## REVISED RESPONSE TO REQUEST FOR ADDITIONAL INFORMATION

### APR1400 Design Certification

Docket No. 52-046

**RAI No.:** 176-8089  
**SRP Section:** 03.11 – Environmental Qualification of Mechanical and Electrical Equipment  
**Application Section:** 03.11  
**Date of RAI Issue:** 08/31/2015

**Figure 3A-1 A Simplified Flowchart for Calculating the Normal TIDs for Equipment Qualification**

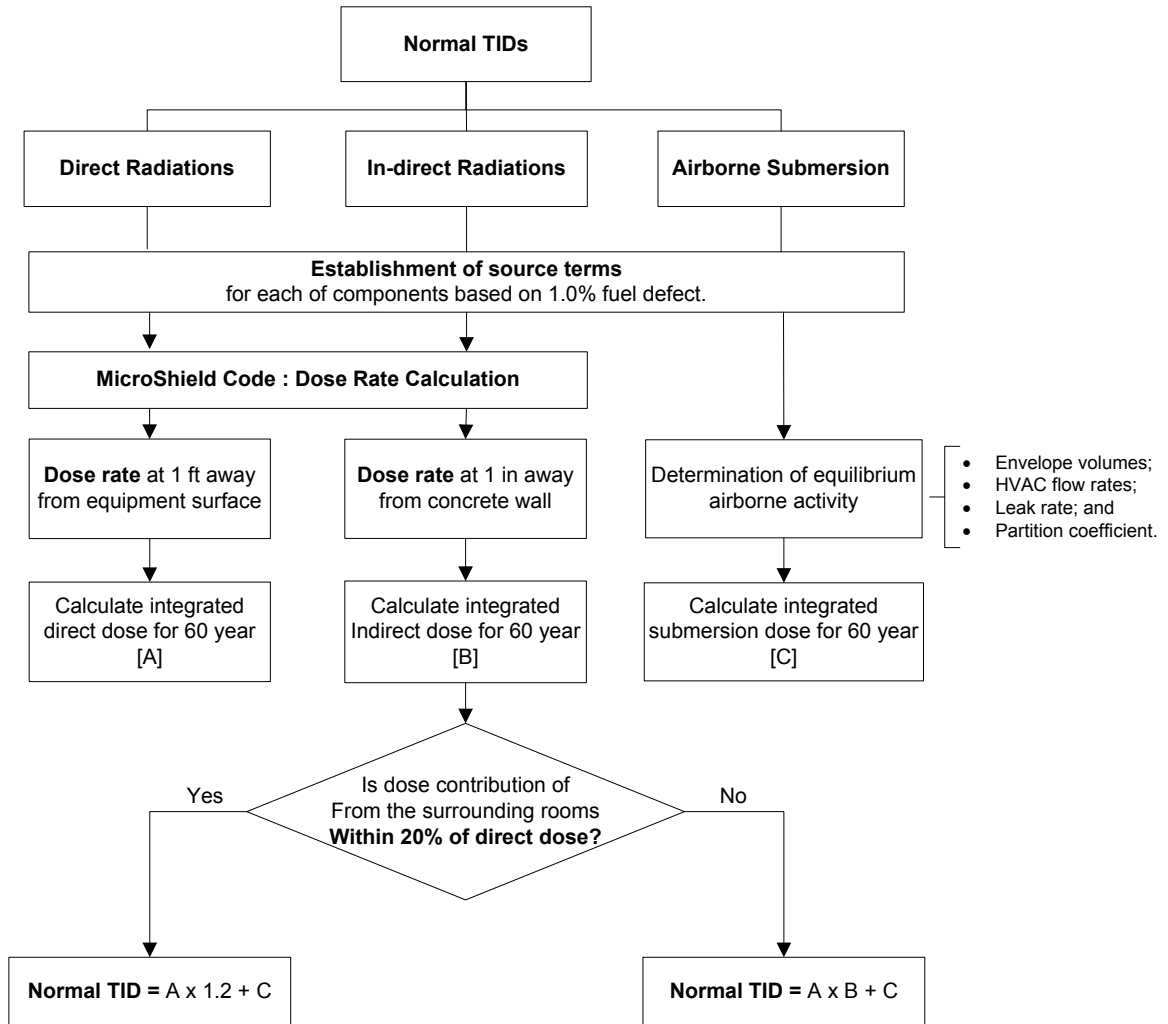
The approach for the above calculations for the determination of the TIDs for equipment qualification consists of three different contributing factors. These factors are summarized below and are presented in a simplified flow chart in Figure A-1 of Appendix A (provided in Attachment 5):

A simplified flow chart for calculating the normal TID values is presented in Figure 3A-1. As shown in Figure 3A-1, the following three dose contributing factors are considered for the determination of the normal TIDs:

- A 20% margin is added to the direct doses to consider dose contributions from the surrounding areas. If the 20% margin is not bounding the all dose contributions from the adjacent sources, the actual dose rates from the adjacent sources are added to the direct doses.

- In accordance with RG 1.89, an additional margin of 10% is added to the normal TID for consideration of the uncertainty of the test.
